## Schematic

## Design change

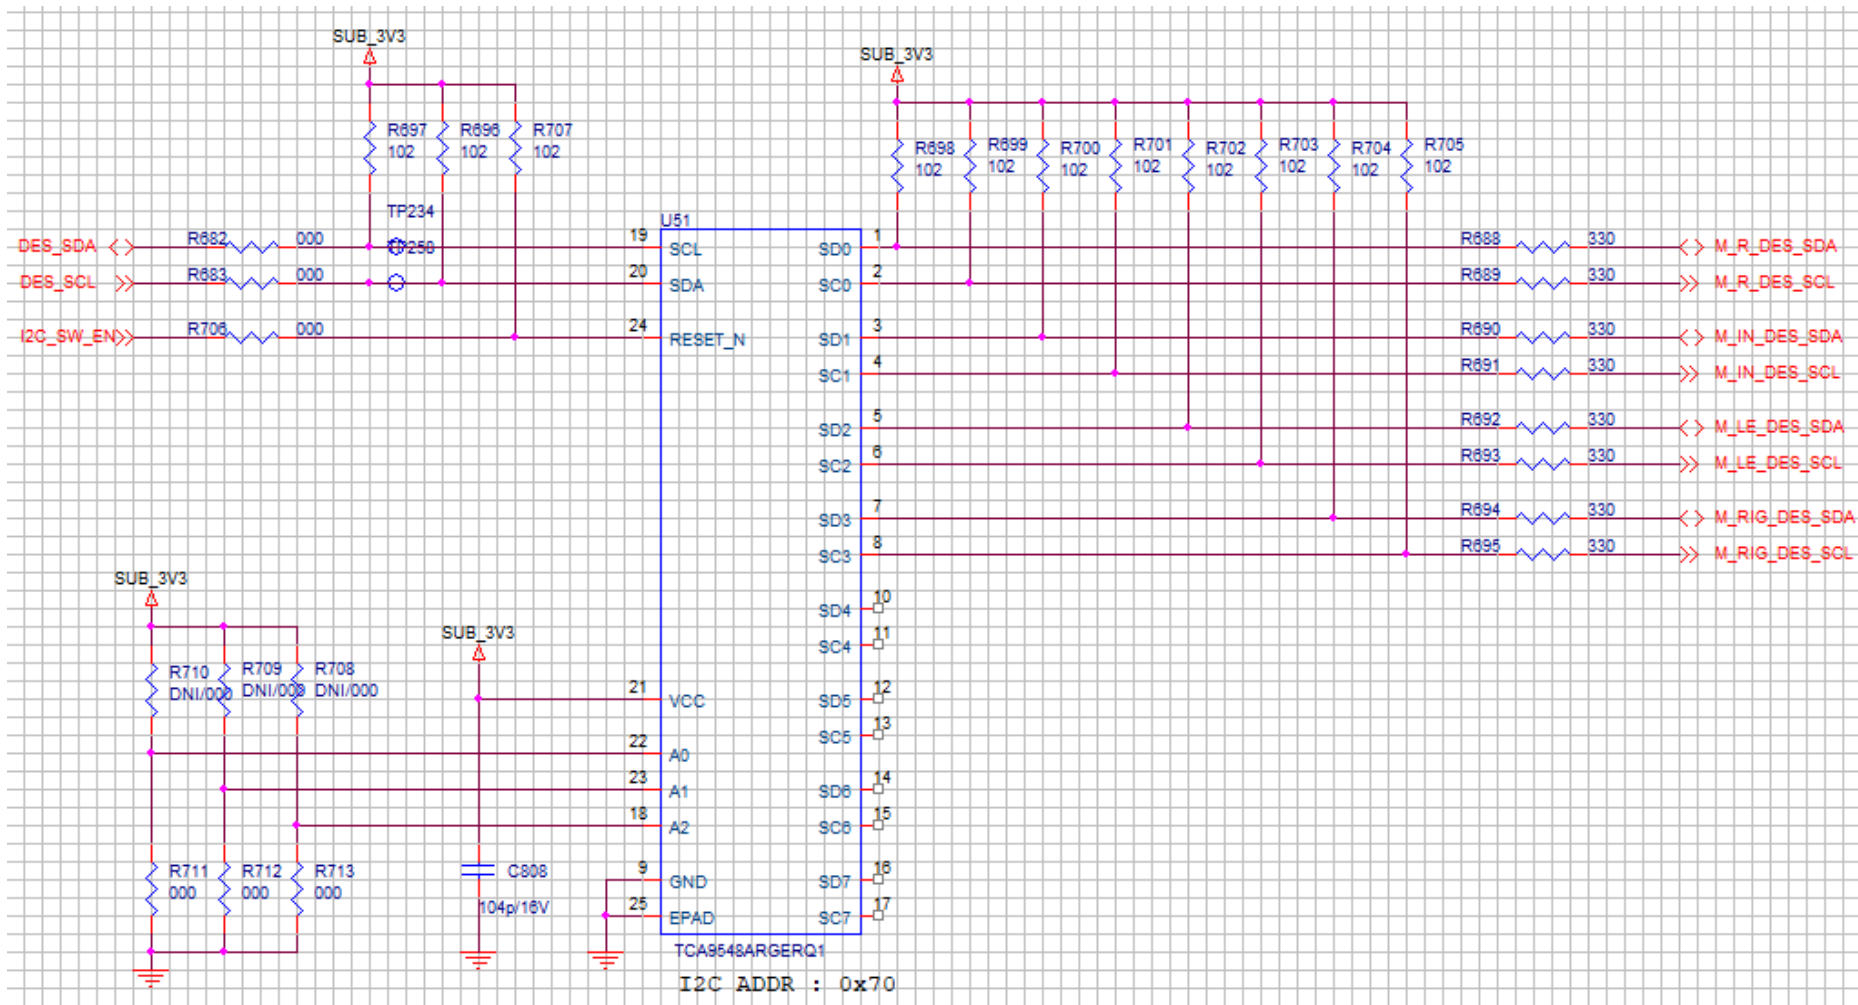
1. R688~R695 : changed from 330ohm to 0ohm
2. Pull-up resistors : tested to 1kohm, 1.8kohm, 4.7kohm, and 10kohm
3. Test channel : Between master(Pin 19/20) and slave(Pin 1/2)
